**Addendum No. 2**

RE: Contract ID: C201797

**Hyde County (B-5015, B-5016, B-5017)**

Bridges No. 10, 24, 31, 39, 42, 46 and 49 on NC-12

159

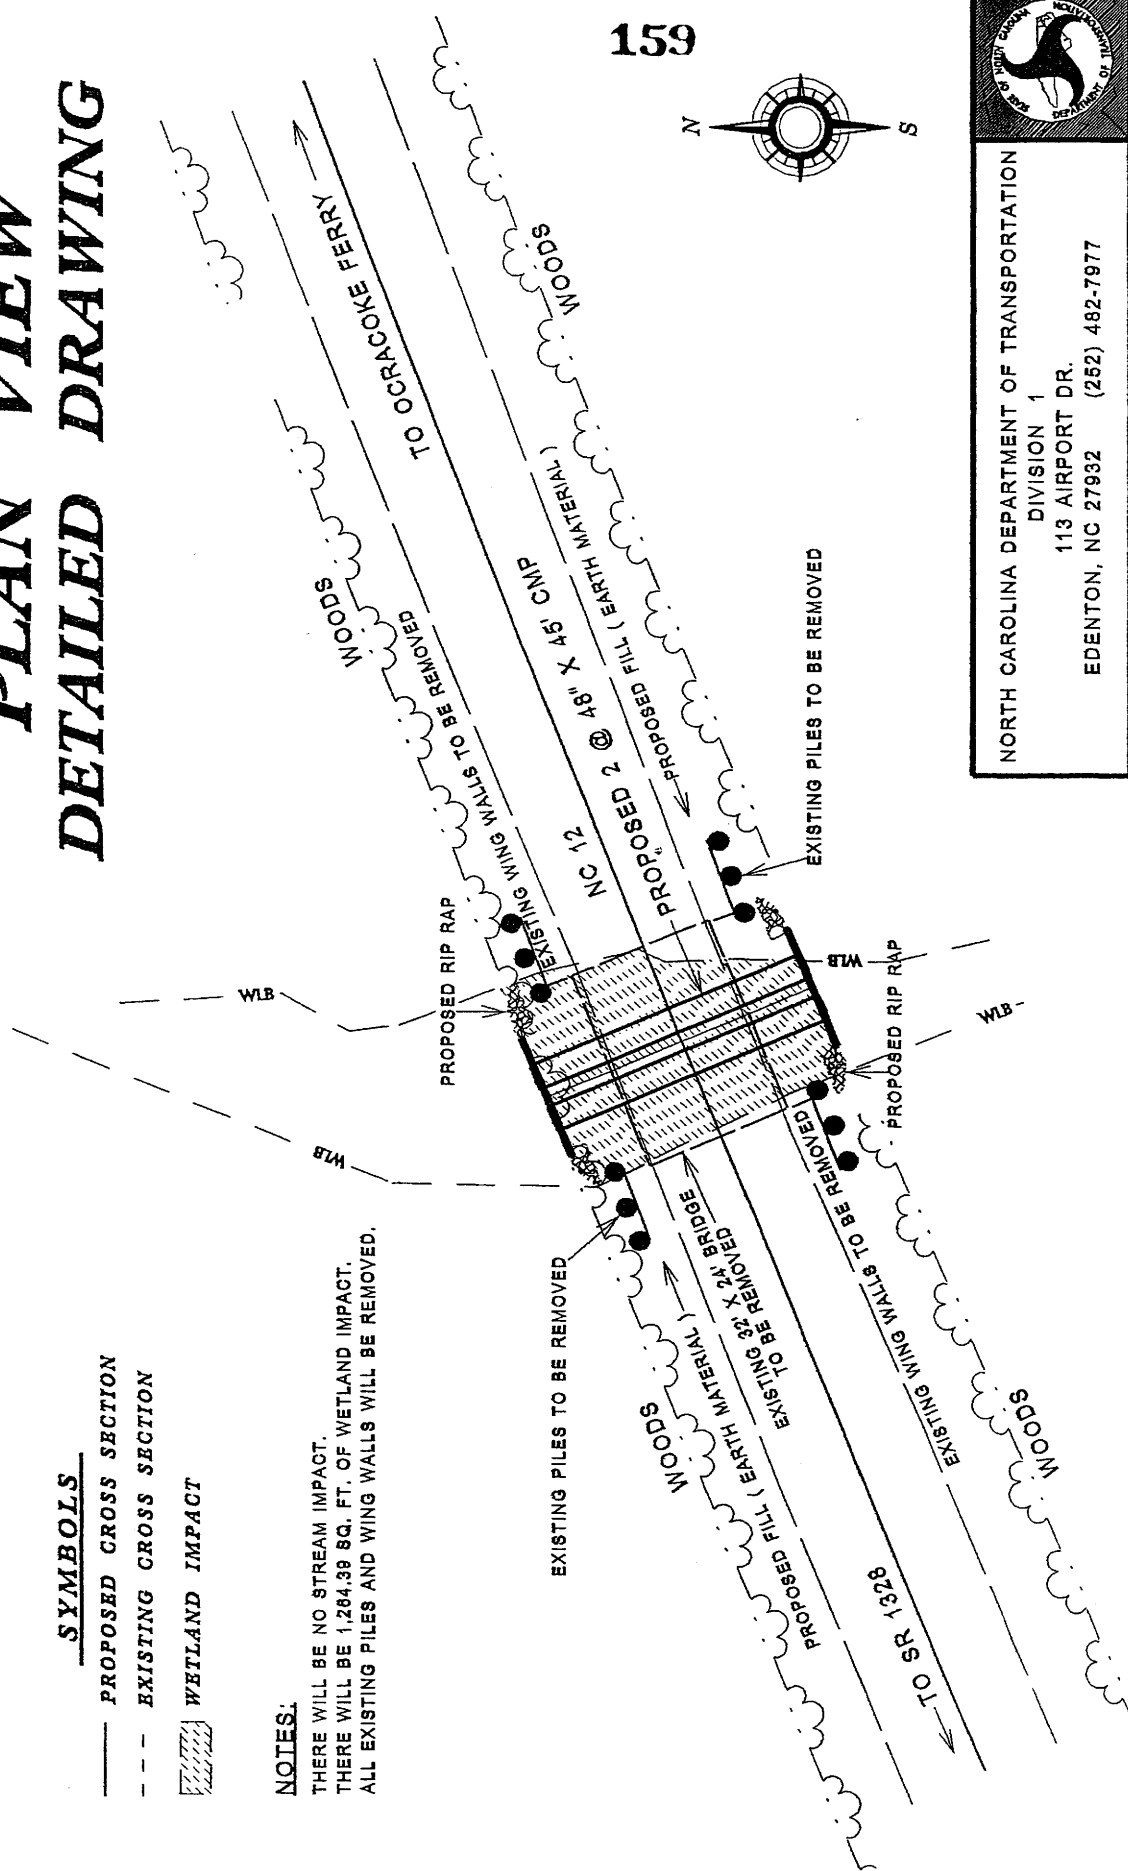
Revised 7-5-07
